International Code Council

**ICC 500-2020 edition
Public Input Agenda with
Committee Votes and Public Comments
based on input received
on 2014 edition of the
ICC 500 Standard**

**For February, 2020
2nd Meeting – Teleconference**

Matrix for ICC 500 proposals with Committee Votes or Public Comments

Figure 504.1.1

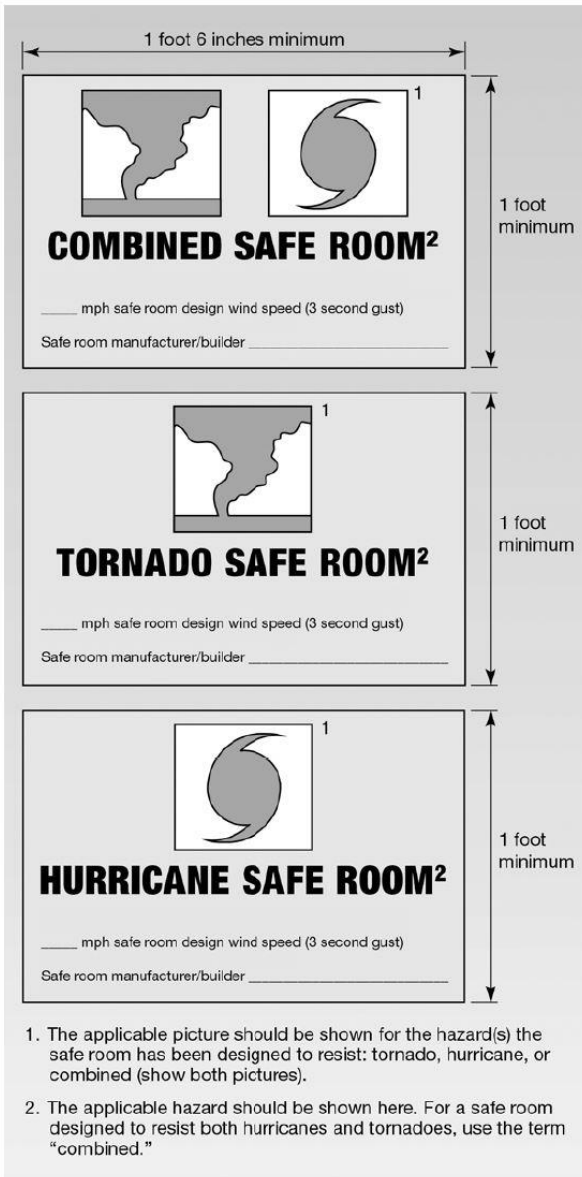
Add “Tornado Shelter Design Capacity: 1,500” to Figure 504.1.1.

Add “Tornado Shelter Design Capacity: 2,500” and “Hurricane Shelter Design Capacity: 1,500: to the top sign in Figure 504.1.2.

Add “Tornado Shelter Design Capacity: 400” to the middle sign in Figure 504.1.2.

Add “Hurricane Shelter Design Capacity: 2,000” to the bottom sign in Figure 504.1.2.

Committee Action: As modified (7-0 meeting) (12-0 electronic vote)

FIGURE ~~303.2~~ 303.1.1

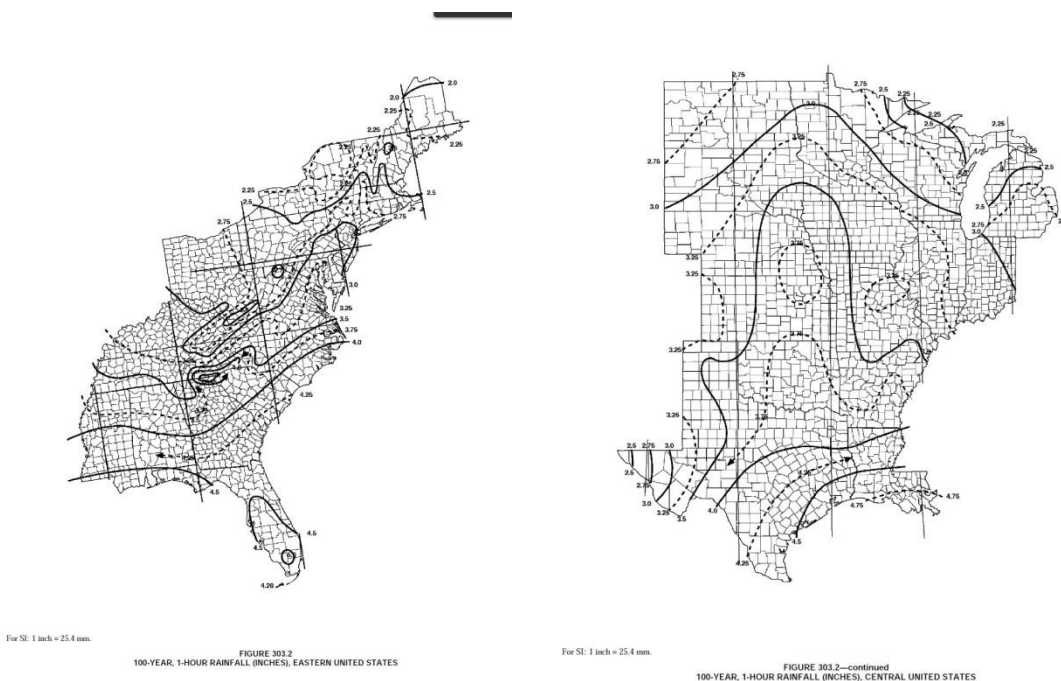
303.1.1. Rainfall rate. The rainfall rate shall be determined by adding 6 inches (152.4 mm) of rainfall per hour to the rainfall rate established from Figure ~~303.2~~ 303.1.1.

Reason: Figure 303.2 is referenced in Section 303.1.1 and not in Section 303.2. Section 303.2 has nothing to do with the figure.

FIGURE 303.2 303.1.1
100-YEAR, 1-HOUR RAINFALL (INCHES), EASTERN/CENTRAL UNITED STATES
(Add figure for Western United States, Hawaii, Alaska and the American territories listed in ICC 500 Figure 304.2.1) 10-19-2018: See IS-STM-07-15-18 for Hawaii Map

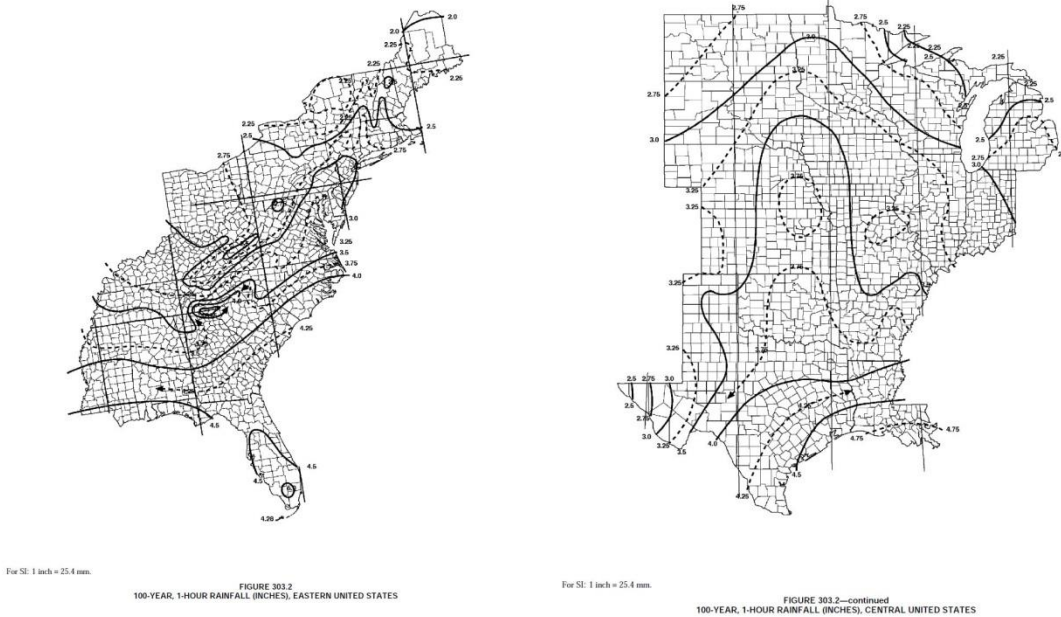
303.1.1. Rainfall rate. The rainfall rate shall be determined by adding 6 inches (152.4 mm) of rainfall per hour to the 100-year, 1-hour rainfall rate established from Figure ~~303.2~~ 303.1.1. For locations not illustrated in the figure, determine the 100 year, 1-hour rainfall rate from approved local weather data.

Committee action: Approval as Further Modified		
	Affirmative	Affirmative with comment	Negative with comment	Abstain with reason
Schultz Vote:		x		
Your comment/reason: 303.1.1 Rainfall rate states “or from approved local weather data”. It is unclear who is the approver of this data?				
No revisions suggested.				
<p>303.1.1. Rainfall rate. The rainfall rate shall be determined by adding 6 inches (152.4 mm) of rainfall per hour to the 100-year, 1-hour rainfall rate. The 100-year, 1 hour rainfall rate shall be determined from Figure 303.1.1 or approved local weather data.</p>

Committee action: Approval as Further Modified		
	Affirmative	Affirmative with comment	Negative with comment	Abstain with reason
Scott Vote:		x		
Your comment/reason: Editorial – “Western” in Western United States map caption is spelled wrong (Western)				
Revise as follows:				
<p>FIGURE 303.1.1—continued 100-YEAR, 1-HOUR RAINFALL (INCHES), WESTERN WESTERM UNITED STATES</p>

Figure 304.2(2) SHELTER DESIGN WIND SPEEDS FOR HURRICANES

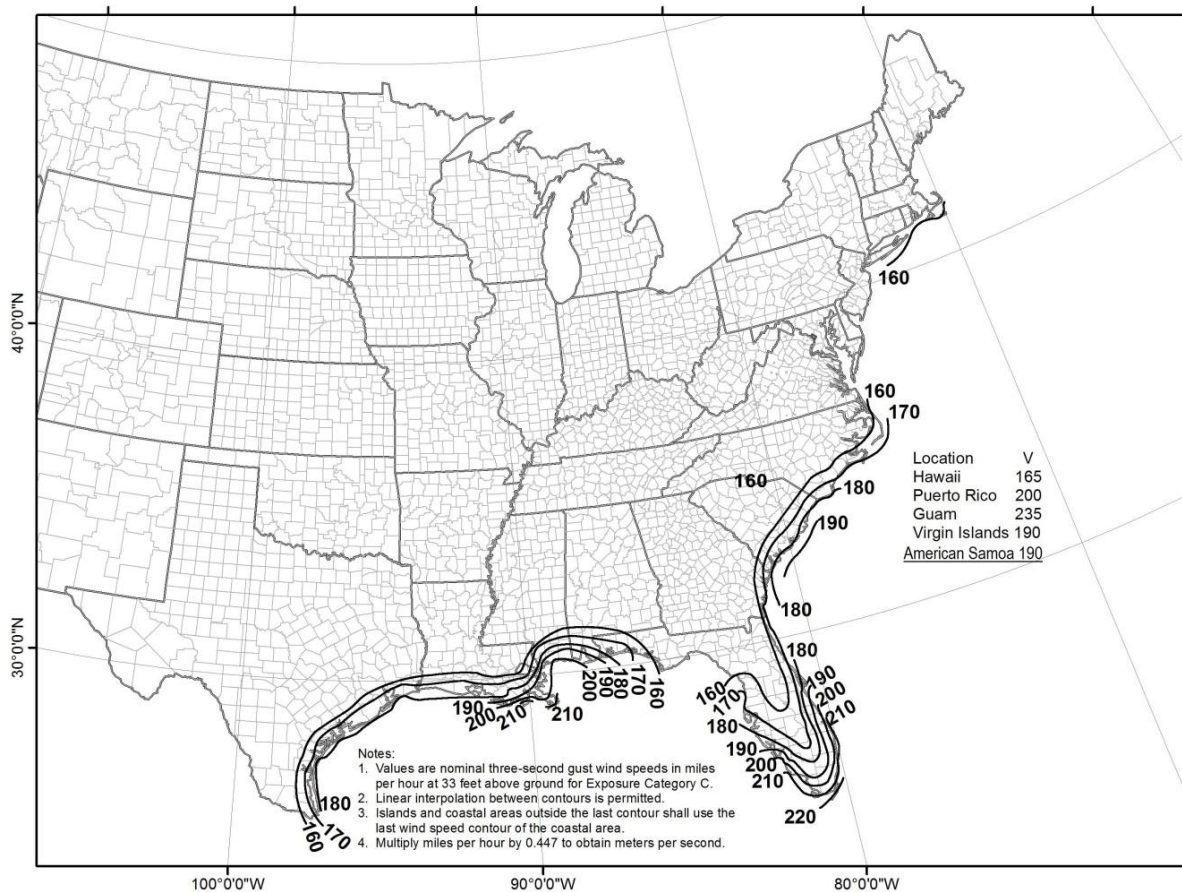
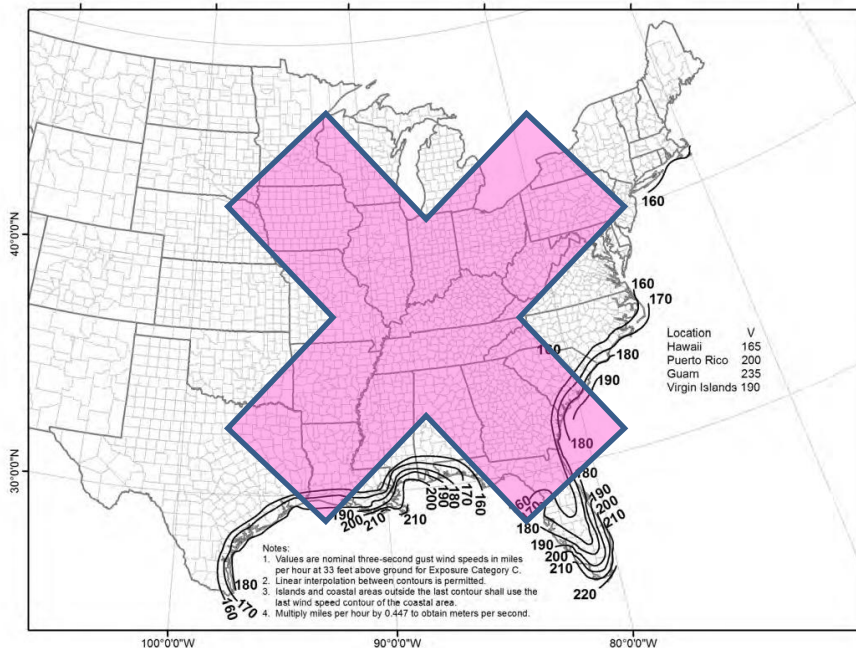
Reason: Currently Figure 304.2(2), the Shelter Design Wind Speeds for Hurricanes, does not specify a design wind speed for American Samoa where hurricanes are the greatest high wind hazard, and a 10,000 year MRI analysis is not currently available. From the ASCE 7 wind speed maps for 300, 700, 1700, and 3000 years, it turns out that the Virgin Islands and American Samoa wind speeds at each of these return periods are almost identical, meaning the hazard curves have a similar shape at the two locations. On the ASCE 7-16 Risk Category IV map,

American Samoa and the US Virgin Islands both have design wind speed of 180 mph. Therefore, the proposed wind speed for American Samoa is the same as the 10,000 year MRI wind speed that is currently used for the US Virgin Islands, 190 mph.

Committee Action: Approved as Modified (10-0)

Notes: Will also revise name for US Virgin Islands and add Commonwealth of the Northern Mariana Islands and American Samoa to full map. ARA will provide revised map for standard.

Rotate maps to landscape in final draft.

FIGURE 304.2(2)
STORM SHELTER DESIGN WIND SPEEDS, V, FOR HURRICANES

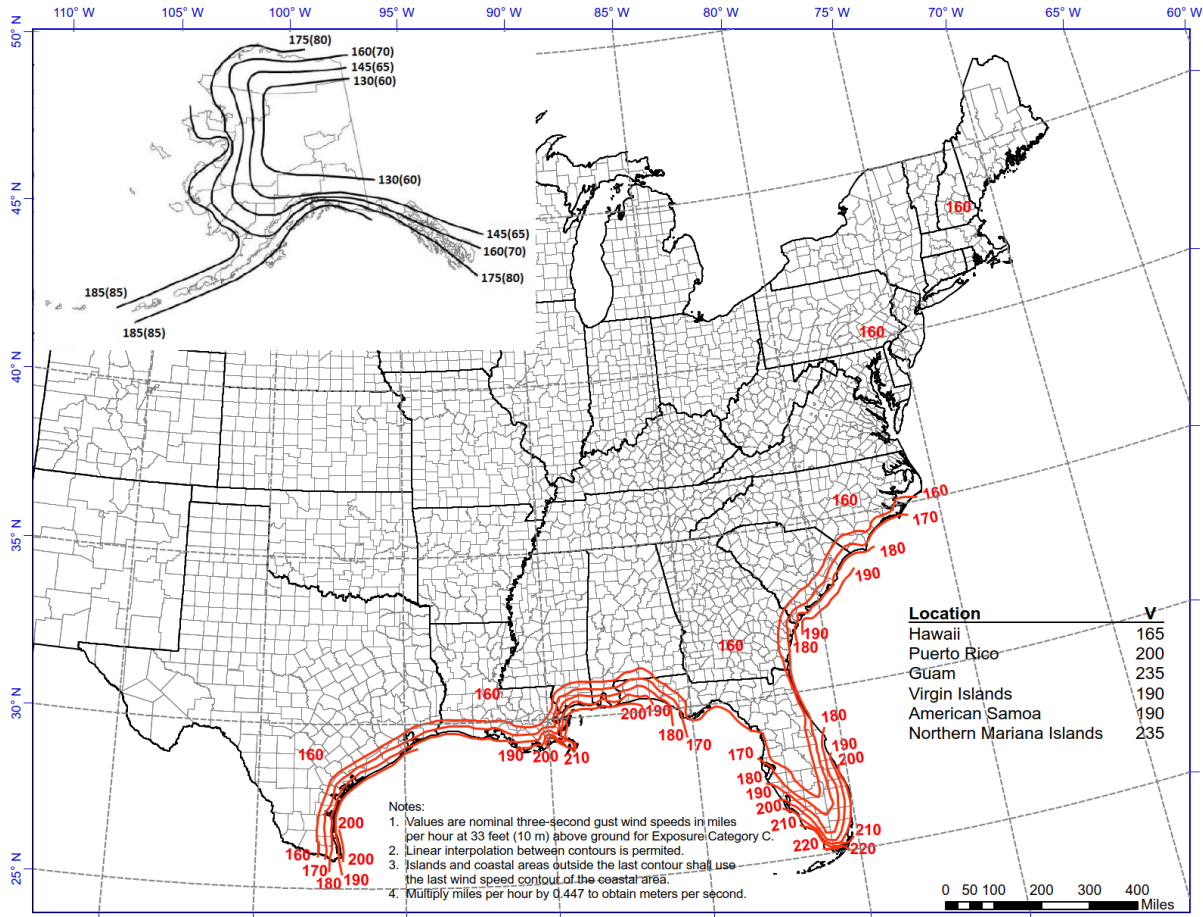
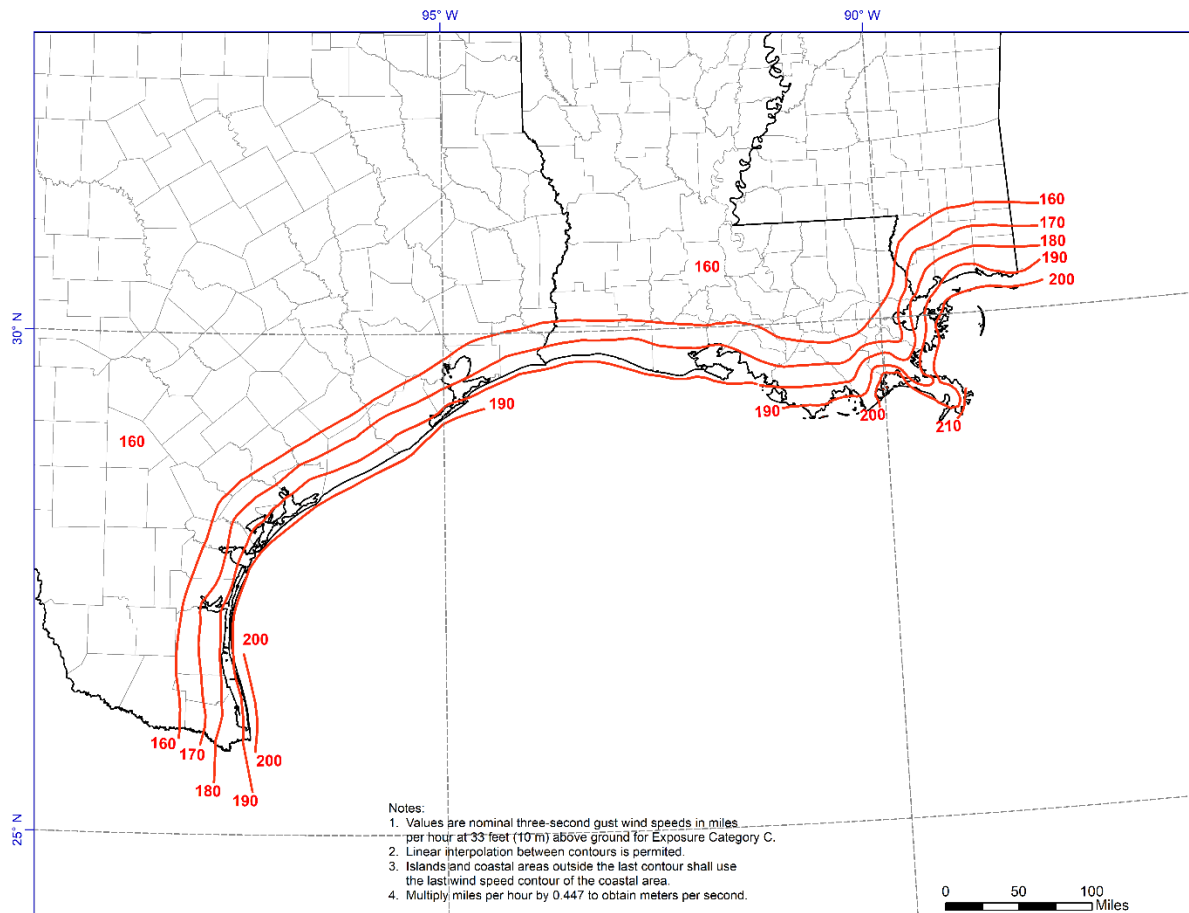
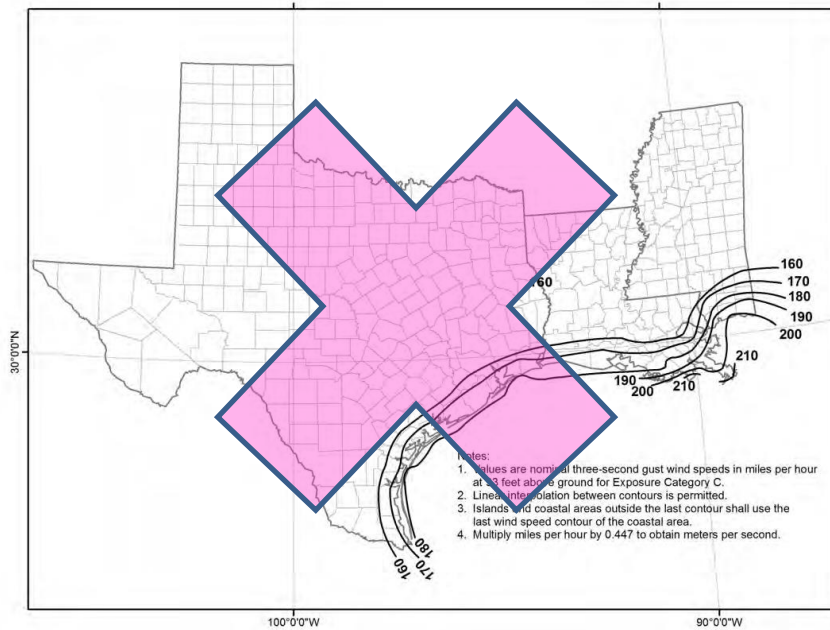
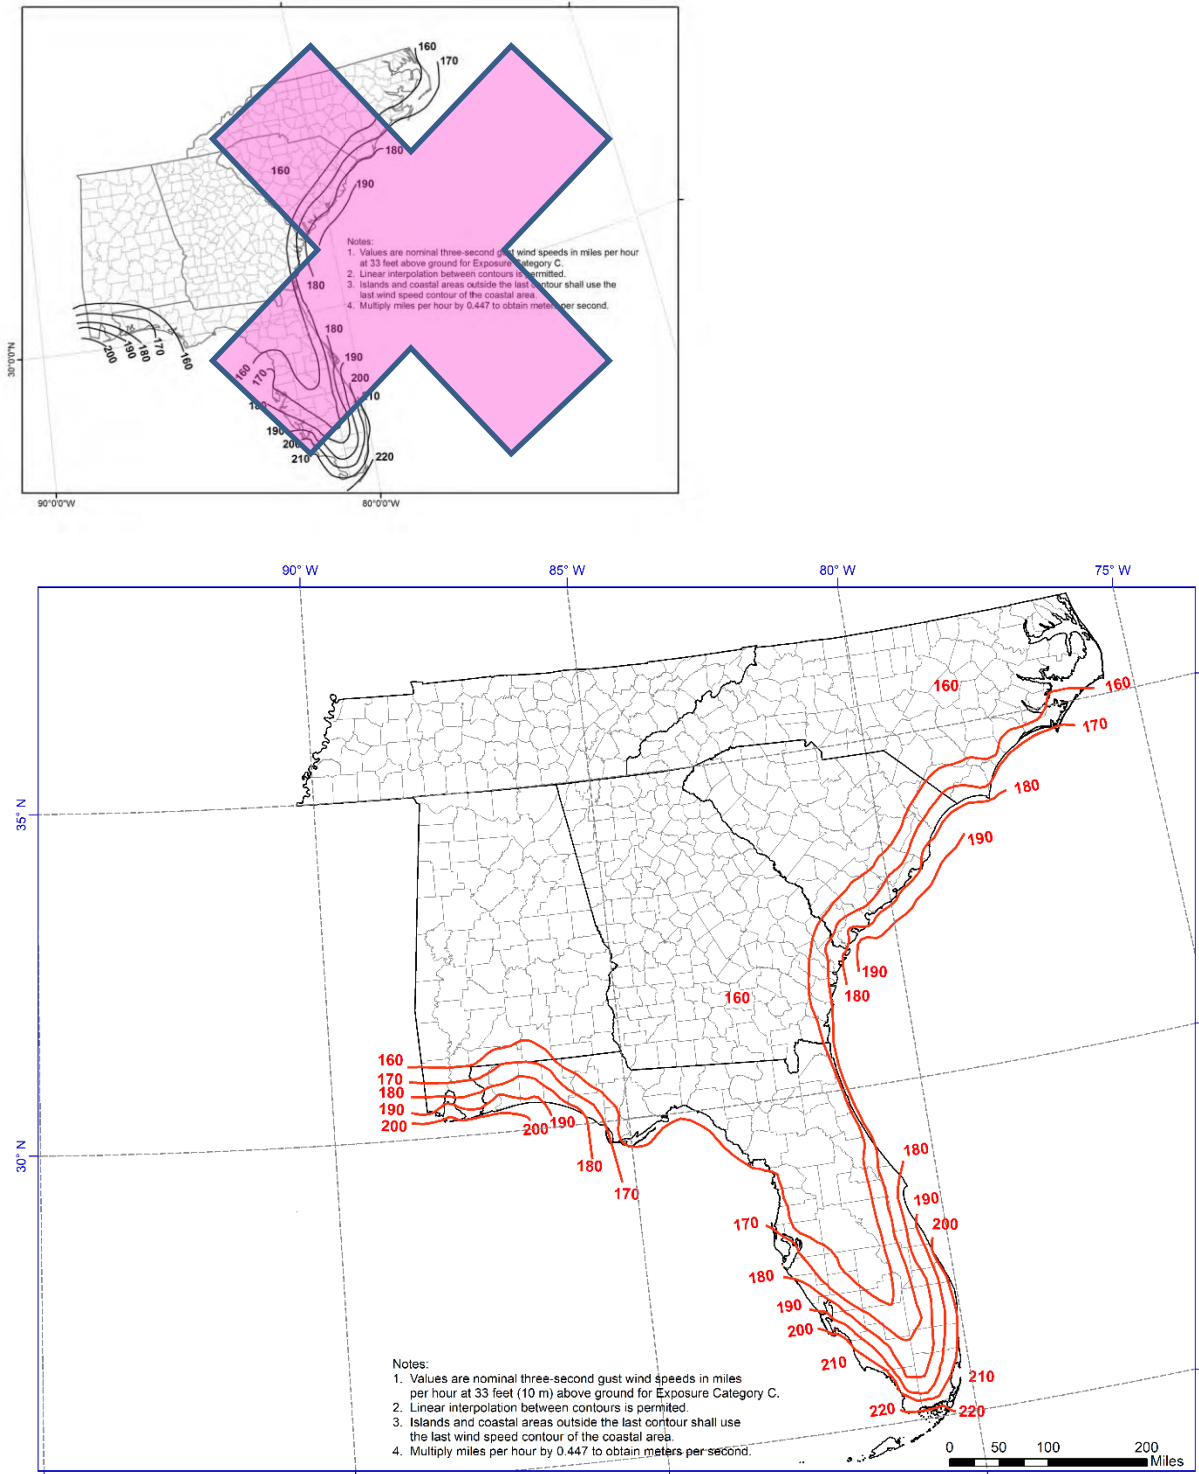
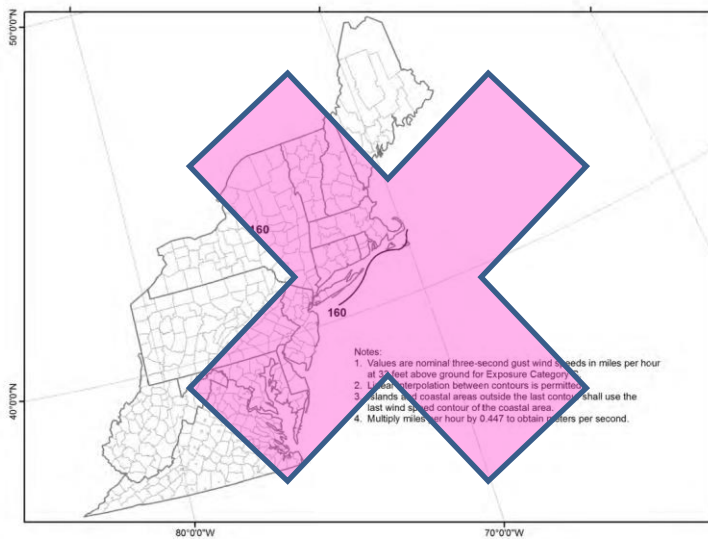
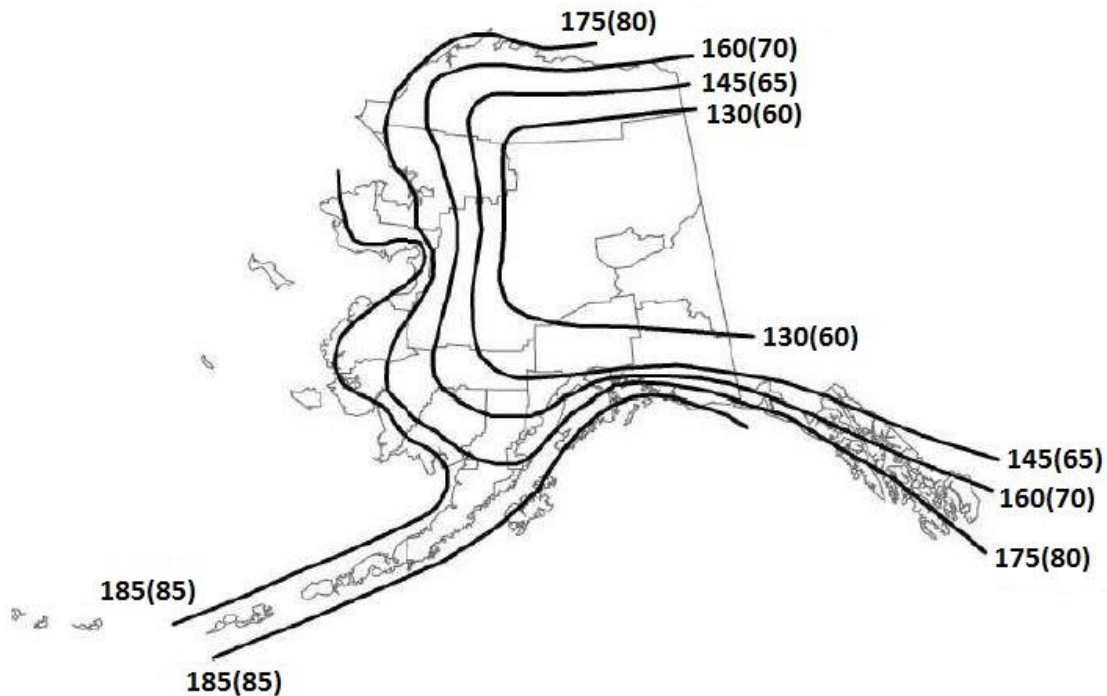
Delete four current maps and replace with the following

Committee Reason: Revised maps to coordinate with latest information for hurricane winds. Add Alaska because that state is affected by hurricane winds. Full list of islands is needed.

FIGURE 804.9.6(1) ~~SHUTTERS OR~~ OTHER IMPACT PROTECTION SYSTEMS

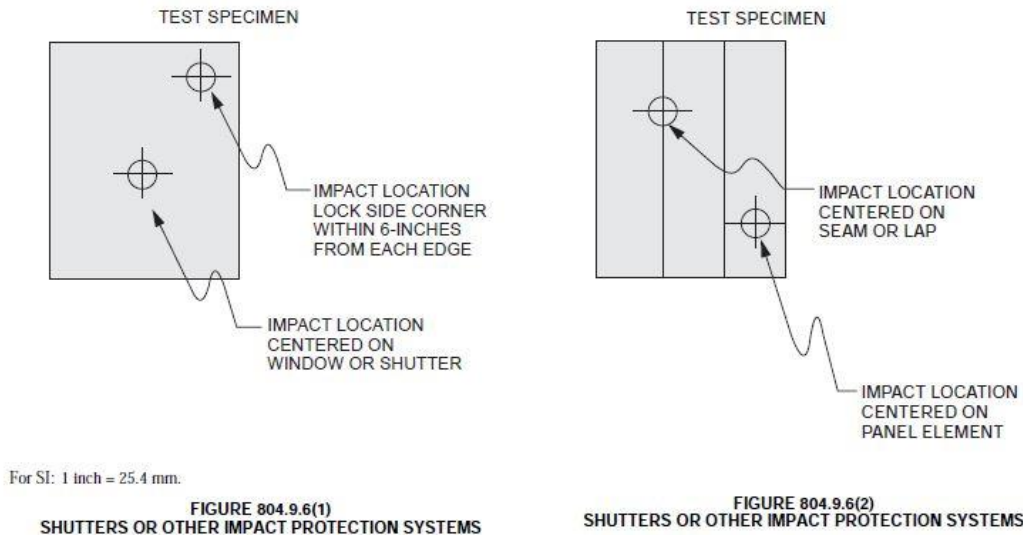
804.9.6 Other Impact-protective systems. All ~~shutter assemblies and~~ other *impact-protective systems* shall be impacted in the center of the closed opening, and at one interface corner as detailed in Figure 804.9.6(1). Panels and interface joints shall be impacted as shown in Figure 804.9.6(2). Interface hinge joints and primary latches, where present, shall be impacted as shown in Figure 804.9.5(2) on an additional specimen. All ~~shutter assemblies and~~ impact protection systems that include swinging door assemblies with latching hardware shall be tested in accordance with Section 804.9.5.

Where an interior stud or support is present, additional impacts shall be performed within 3 inches (76.2 mm) of the stud/ and support, and directly on the stud support, as detailed in Figure 804.9.2(1) or 804.9.2(2).
